**PARK CITY REGULAR PLANNING COMMISSION MEETING
SUMMIT COUNTY, UTAH
September 8, 2021**

Sommet Blanc (B2 East) - CUP & MPD Amendment
Exhibit A - Proposed Massing Changes in Context
September 8th, 2021

Sommet Blanc (B2 East) - CUP & MPD Amendment
Exhibit 5 - Hill Glazier Challenges
September 2nd, 2021

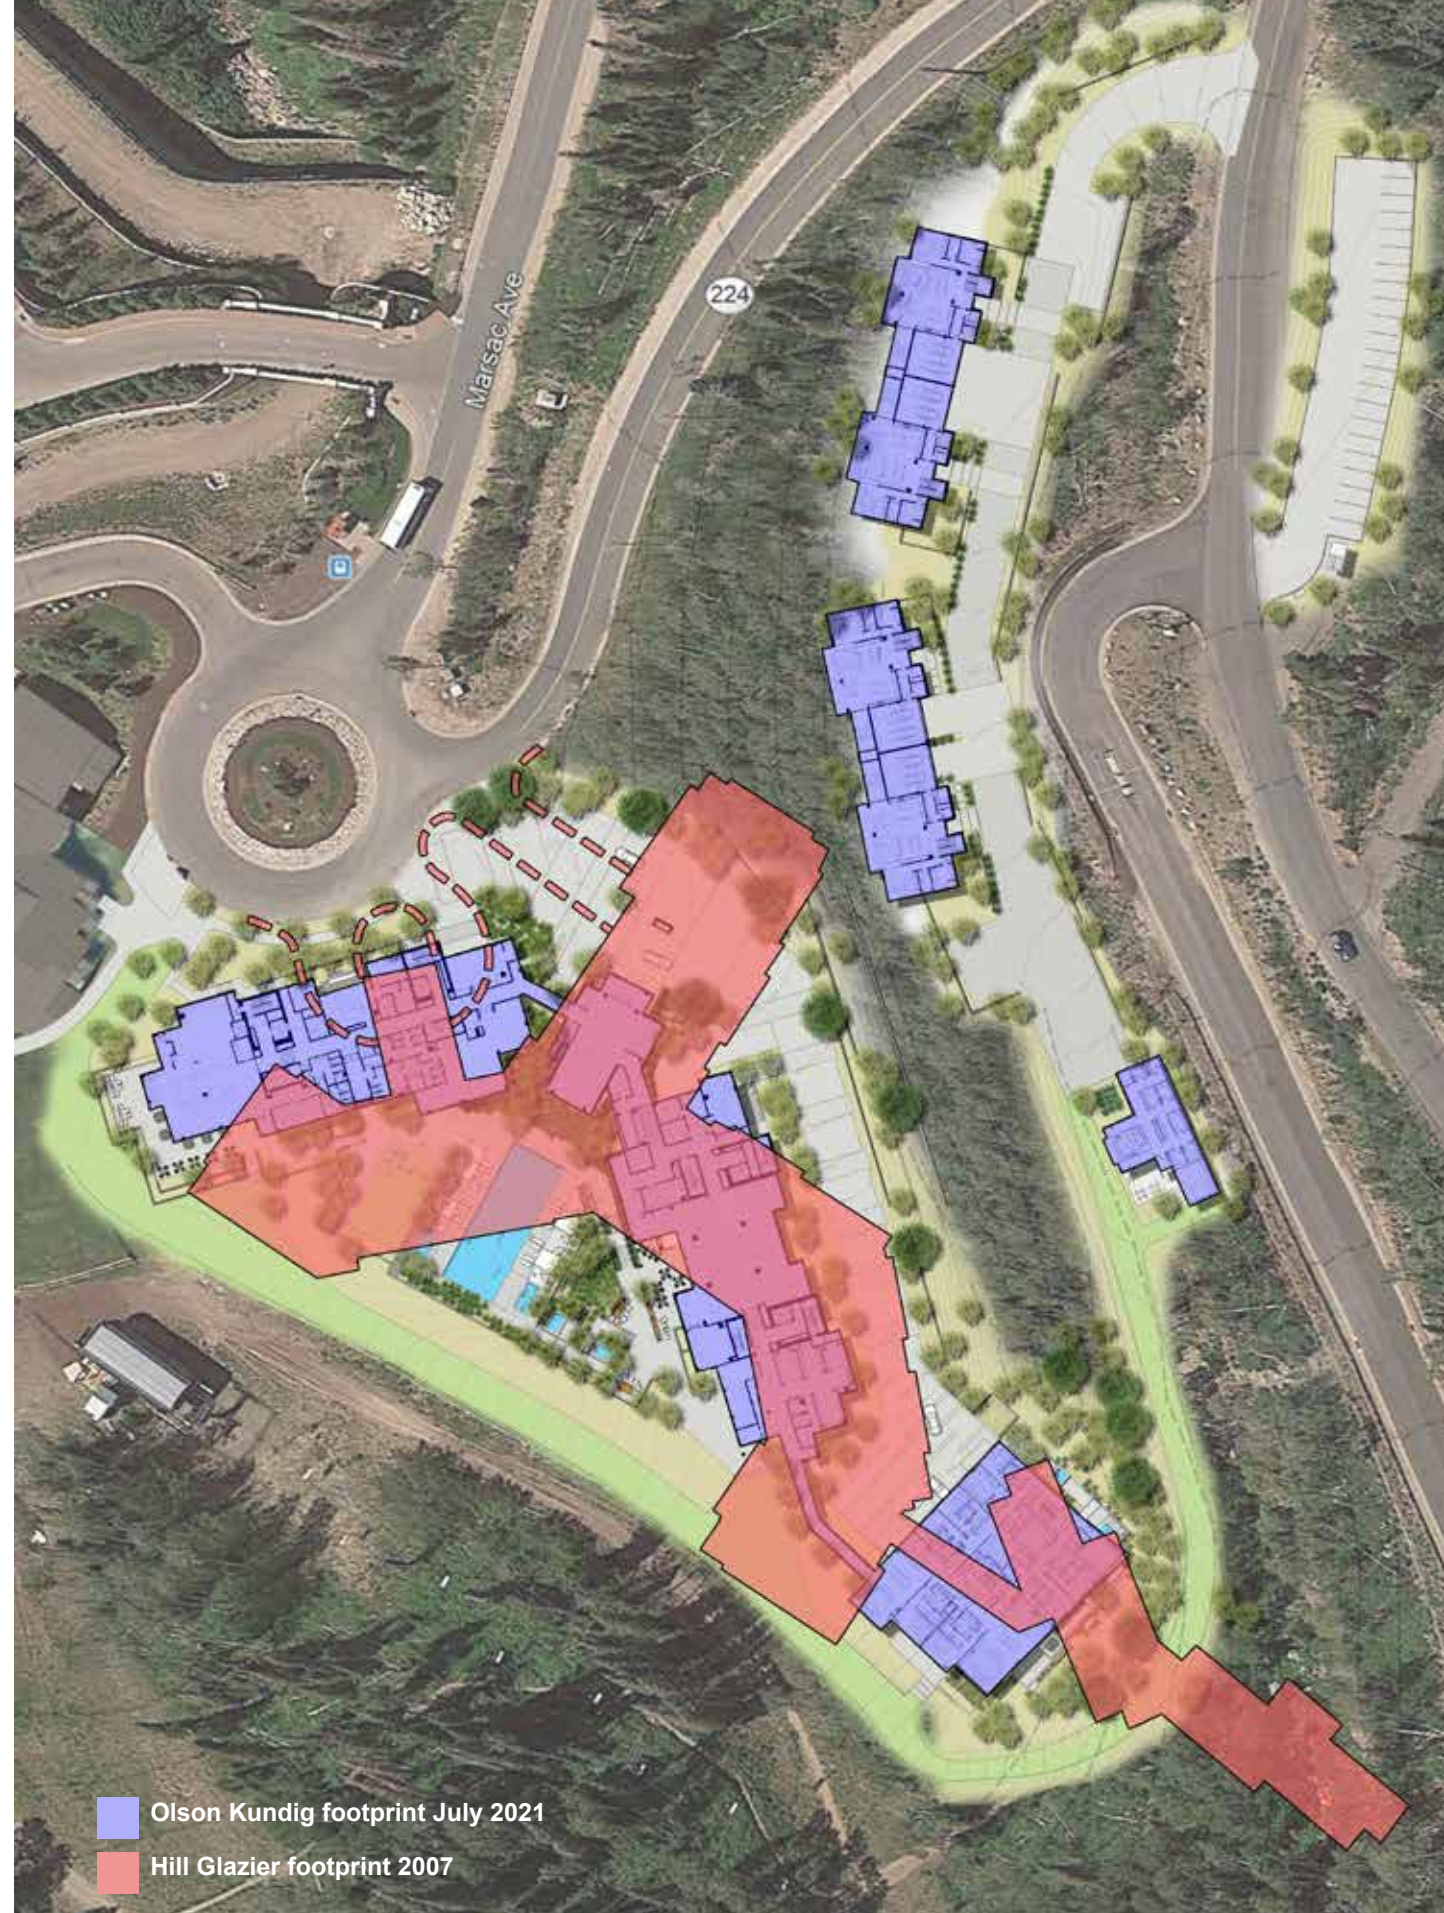
**Massive cut slope
above last villa**
